MEETING DATE: February 25, 2026
TO: Planning Commission
STAFF ORIGINATOR: Steven Gilmore, AICP, Assistant Community Development Director
AGENDA ITEM: PUBLIC HEARING - Hidden Creek South Preliminary Plat and Planned Unit Development
60-Day Deadline: April 21, 2026

Headwaters Land Group, represented by Mr. John Dobbs, has submitted applications for a Preliminary Plat and Planned Unit Development (PUD) Amendment for Hidden Creek South. The subject property consists of approximately 56.52 gross acres located south of Headwaters Parkway within the Headwaters Master Planned Unit Development (PUD) area.

We provide the following comments for the proposed improvements:

1 OVERALL LANDSCAPE PLAN
L1

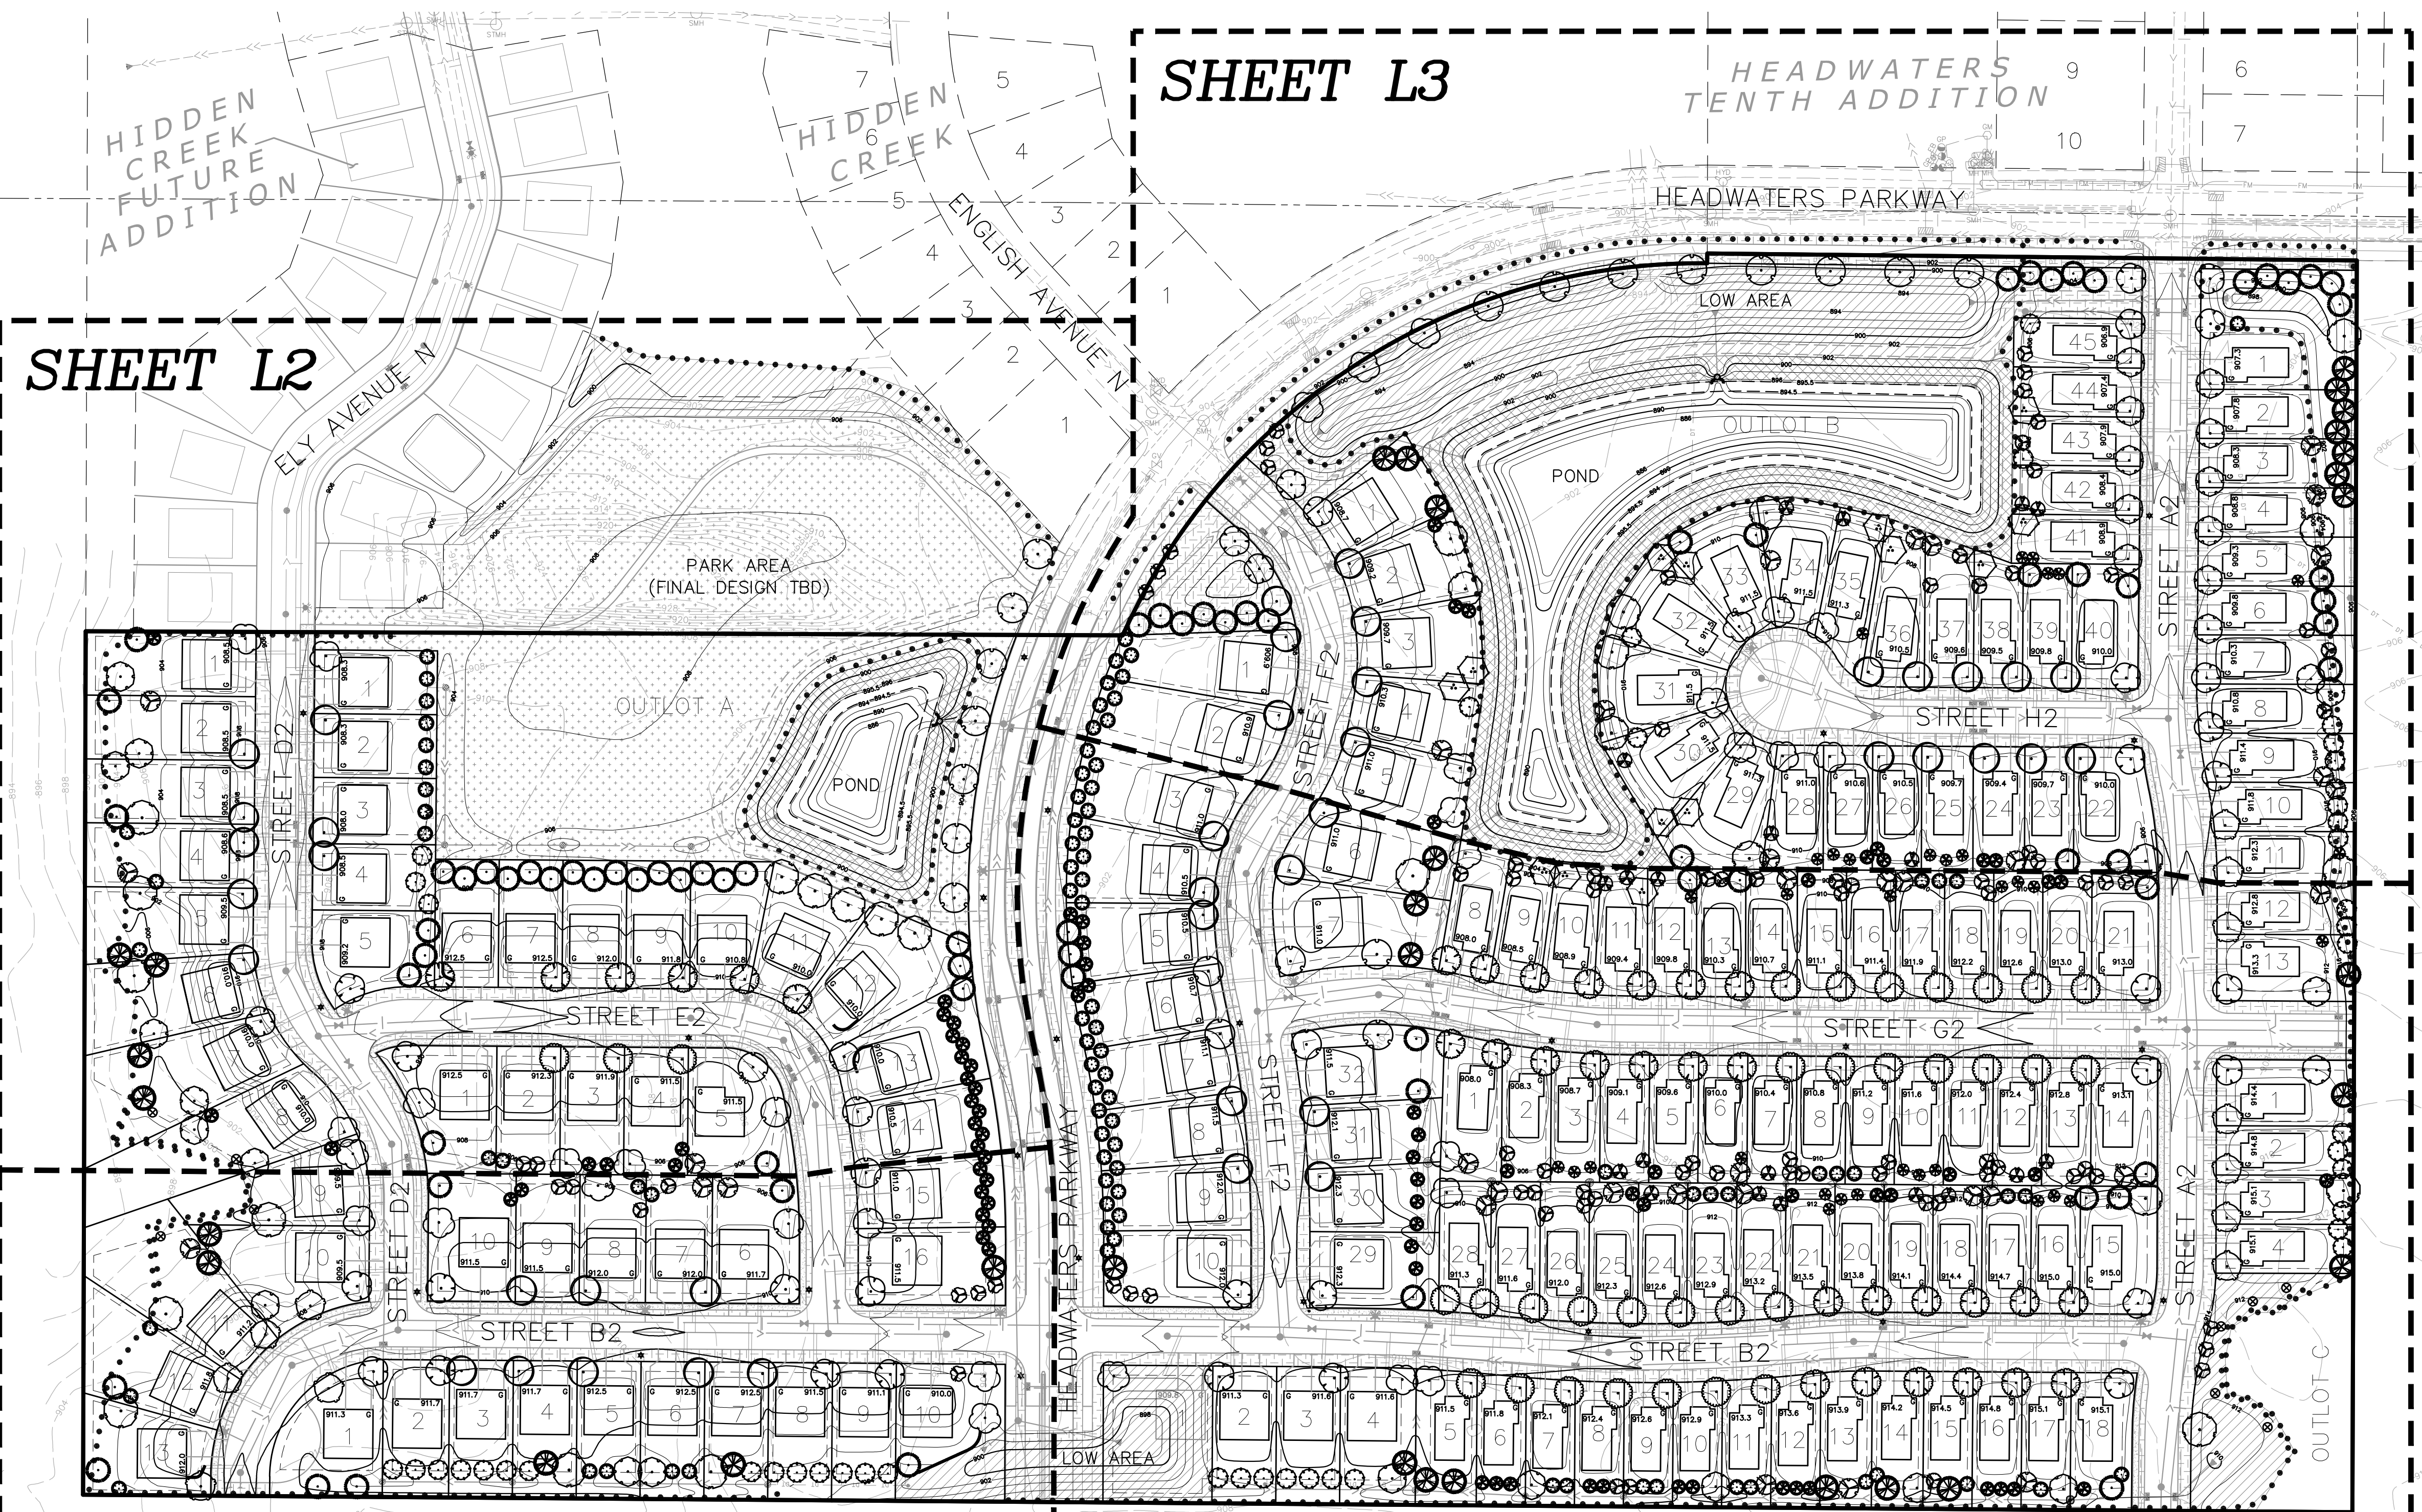
65. Landscape plans shall be reviewed and approved by Planning and Zoning.
66. No landscaping is allowed to be placed in City right of way or drainage and utility easements.
67. Ensure all trees are not in conflict with sanitary/water services, utility mains, or drintile lines.

68. Revise proposed tree locations as noted on the attached markup.
